**BEFORE THE  
FEDERAL COMMUNICATIONS COMMISSION  
WASHINGTON, DC 20554**

**COMMENTS**

ENGINEERING STATEMENT  
ON BEHALF OF  
RED RIVER BROADCAST CO., LLC  
LICENSEE OF  
**KBRR-DT, THIEF RIVER FALLS, MINNESOTA**  
DTV CH. 10 9.7 KW ND ERP 113 METERS HAAT  
IN RESPONSE TO  
SEVENTH FURTHER NOTICE OF PROPOSED RULE MAKING  
MB DOCKET NO. 87-268  
JANUARY 2007

Requested Data Corrections

**FIGURE 1**  
**KBRR-DT AZIMUTH PATTERN**

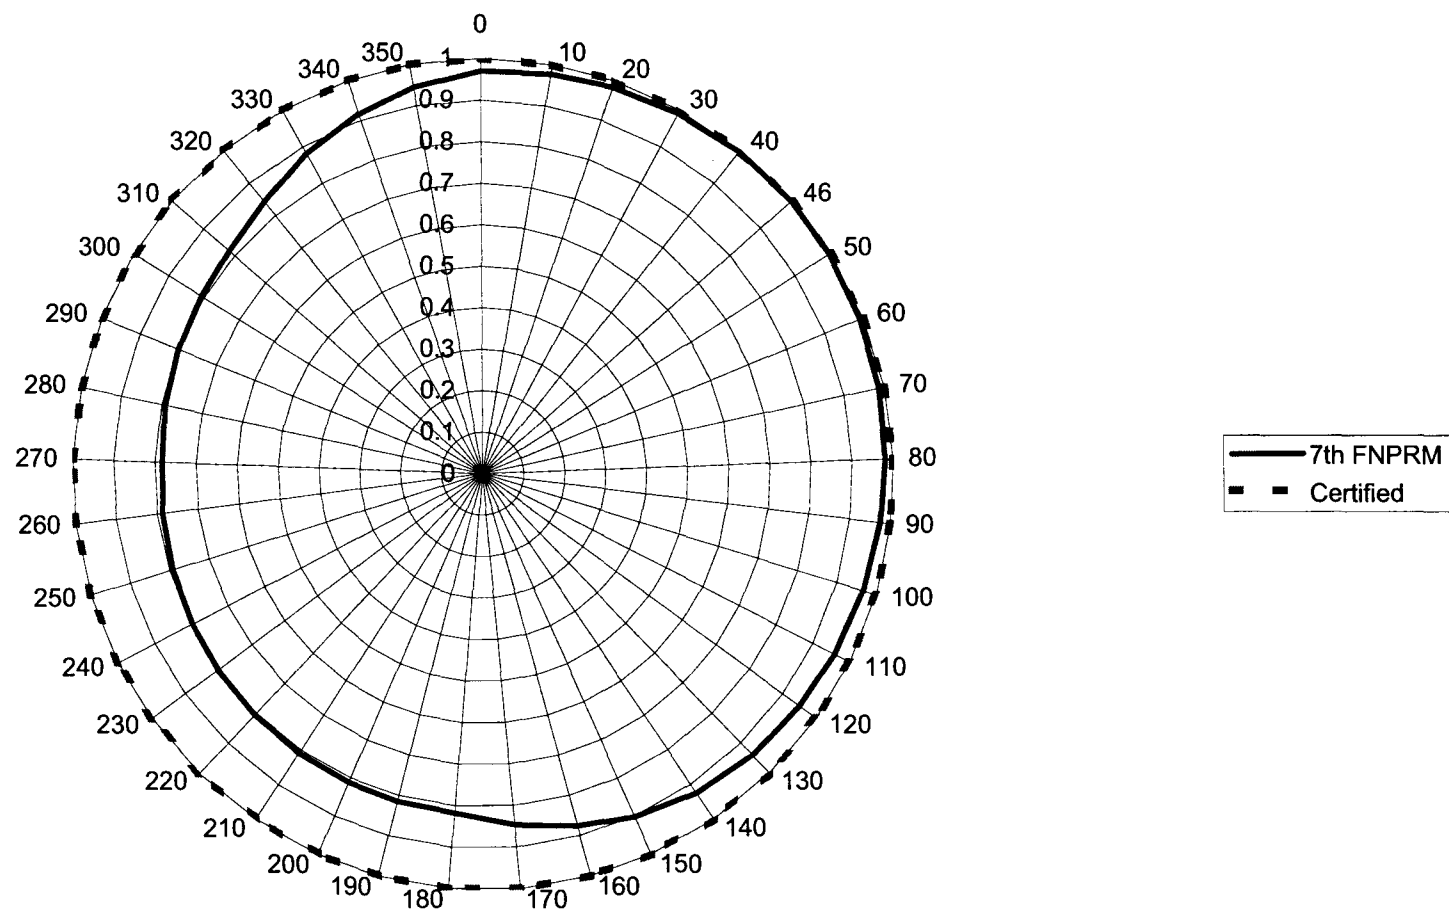
On FCC Form 381, KBRR elected to operate its post-transition DTV station at maximized facilities pursuant to pending DTV application (FCC File No. BPCDT-19991028AAV). KBRR will be operating its post-transition DTV facilities on channel 10, as opposed to the currently authorized DTV channel 32 non-directional operation. However, the azimuth pattern (see Figure 1) as assigned to the KBRR-DT post-transition operation is irregular and not non-directional as is the channel 32 pattern as certified. This irregular pattern as assigned in the Proposed DTV Table of Allotments is unrealistic for a VHF frequency and unable to be produced on an actual antenna. Therefore, KBRR hereby requests that the azimuth pattern as assigned in the SFNPRM be modified to a uniform non-directional pattern.

The requested post-transition DTV parameters as requested in this statement are based on parameters in the proposed DTV Table of Allotments, with the exception of a uniform non-

directional antenna pattern. The requested DTV parameters and associated data for post-transition based on the non-directional KBRR-DT maximized facilities are as follows:

<u>DTV CH.</u>	<u>ERP kW</u>	<u>HAAT meters</u>	<u>Antenna ID</u>	<u>Coordinates NAD 27</u>	<u>Area Sq. km</u>	<u>Population Thousand</u>	<u>Percent Interference Received</u>
10	9.7	113	ND	48° 1' 19"N 96° 22' 12"W	17,817	126	0.1
